CITY OF BATON ROUGE PARISH OF EAST BATON ROUGE

ADDENDUM NO. 4

JONES CREEK ROAD EXTENSION CLEARING AND EARTHWORK

CITY-PARISH PROJECT No. 12-CS-HC-0060A

SHEET 2

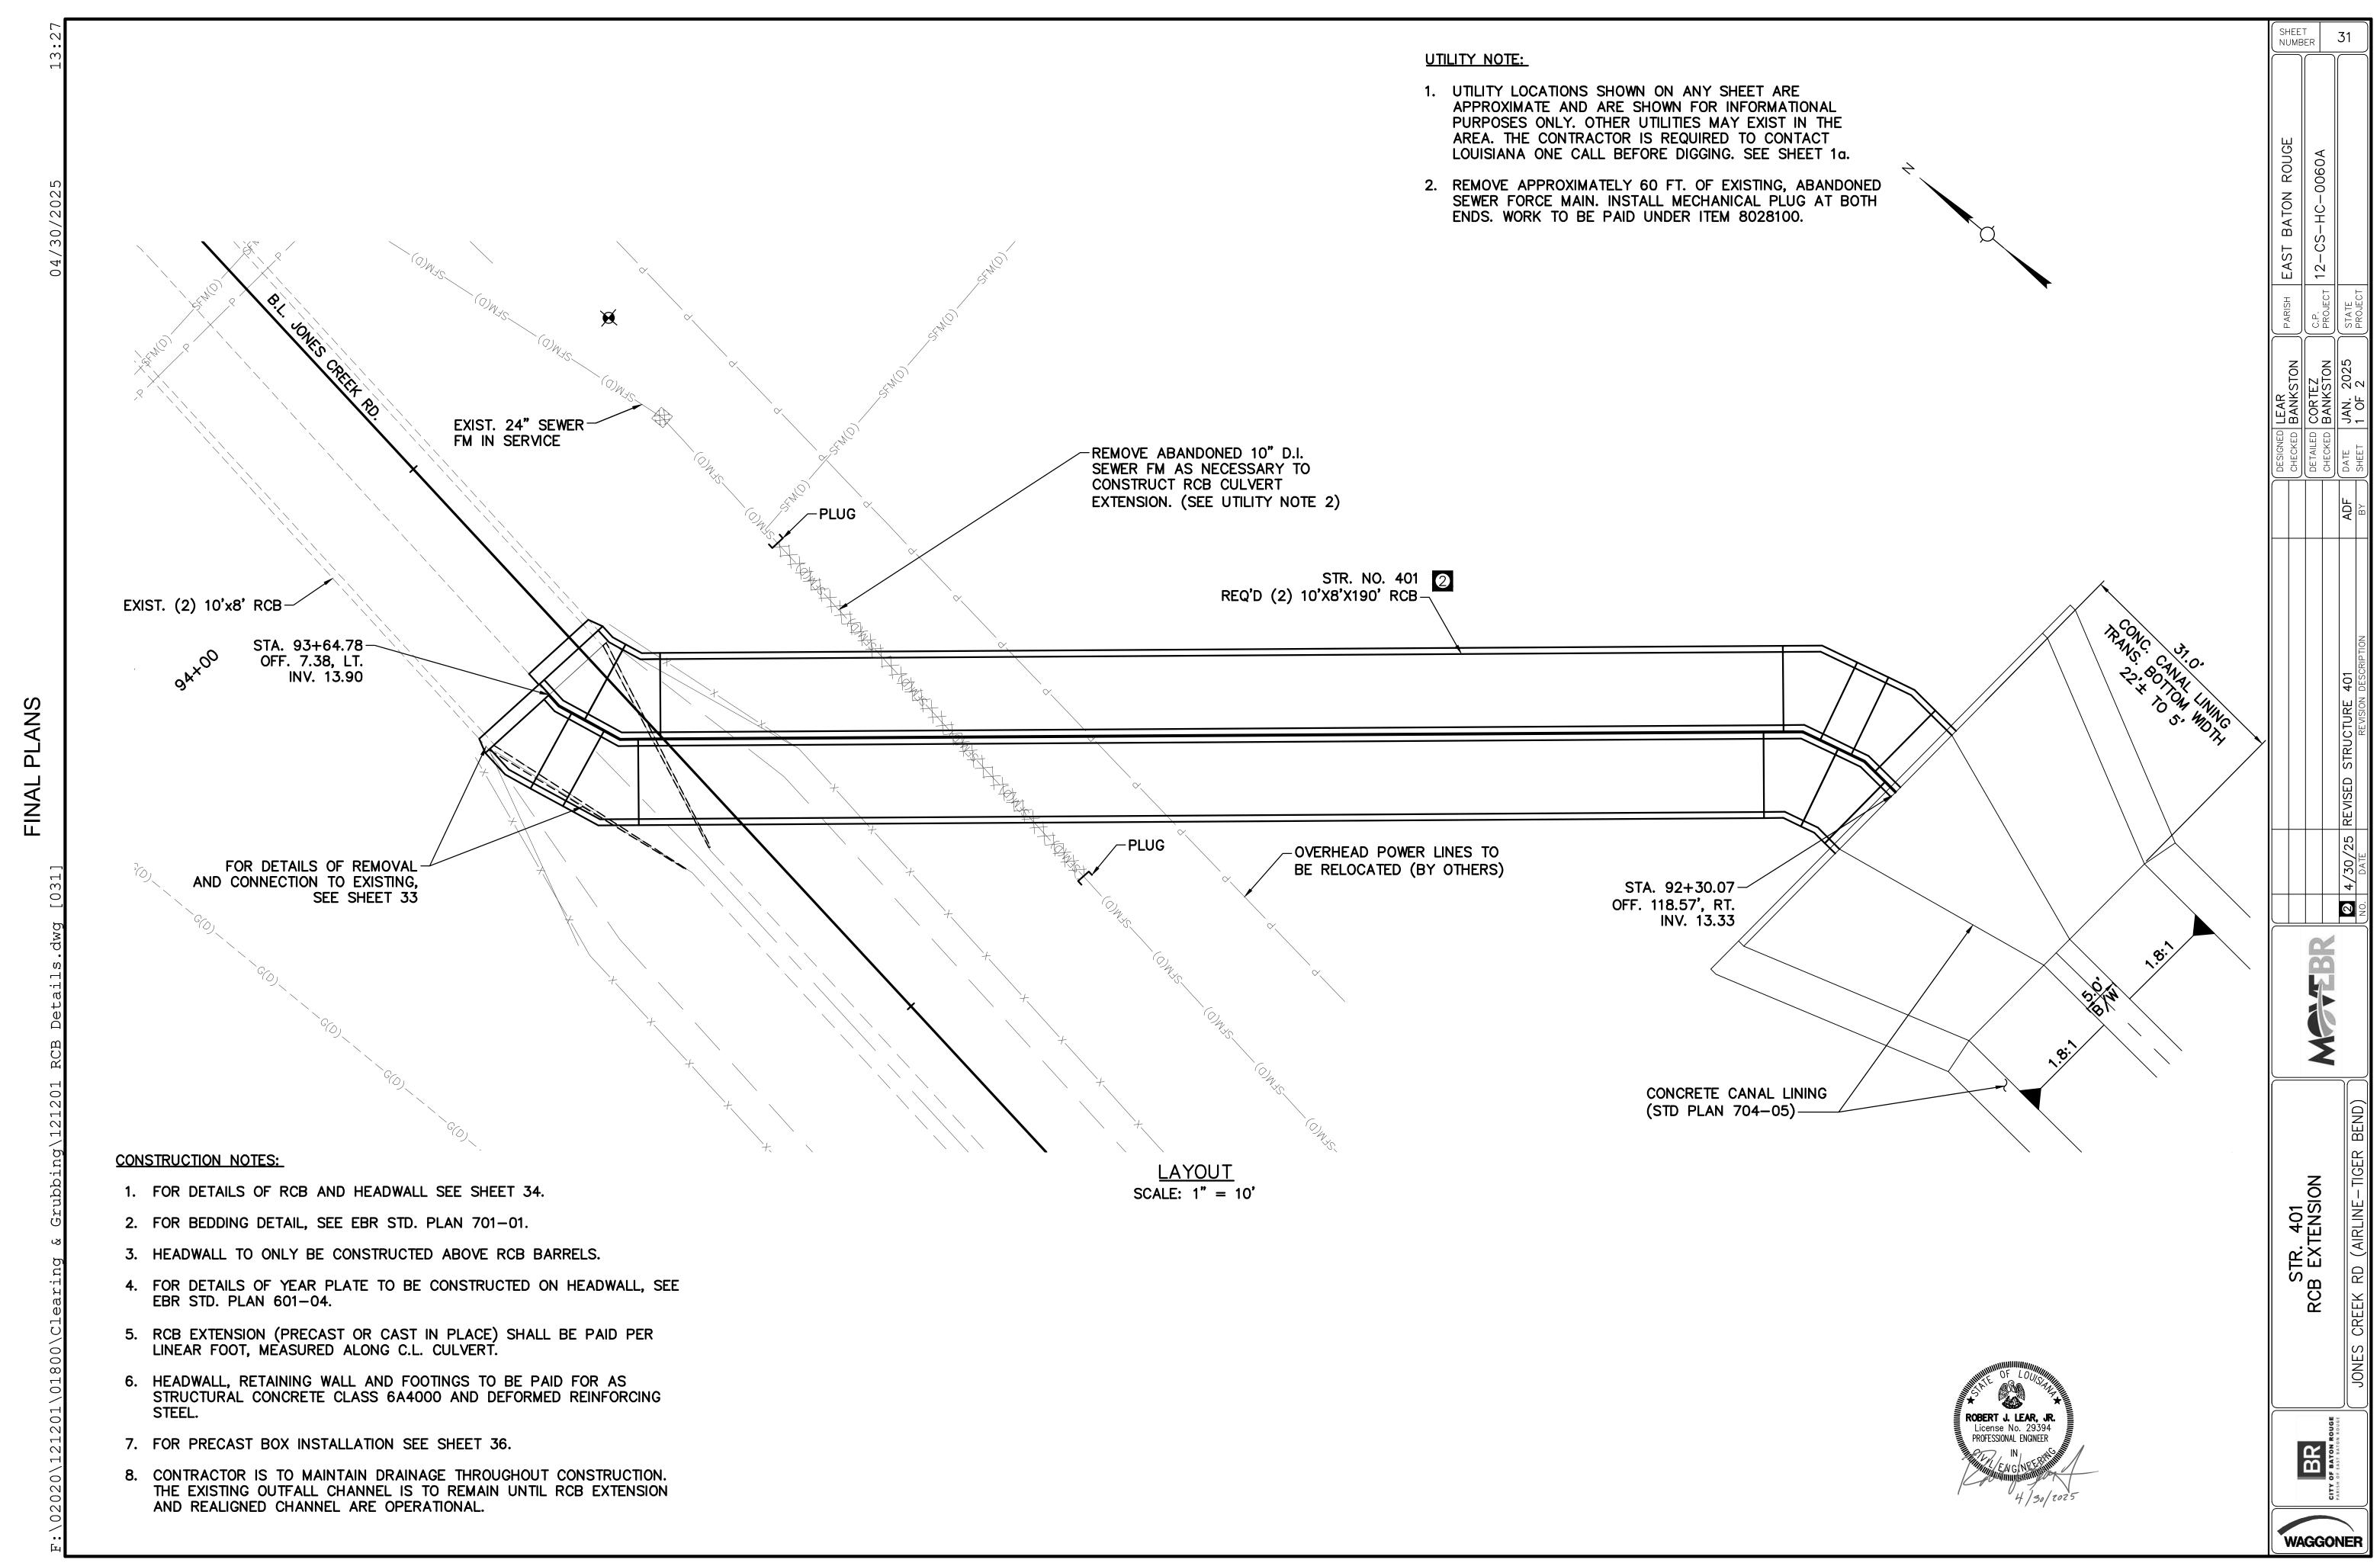
Replace Plan Sheet 2, entitled Summary of Estimated Quantities, with the attached Plan Sheet 2. Revised 4/30/2025. (Attachment B).

The schedule of items, summary of drainage structures, and plan sheet 31 show 10'x8' RCB at 308 LF. Plan sheet 24, shows 380 LF. It appears that 380 LF is the correct amount. Please advise.

See revised plan sheets included in this addendum.
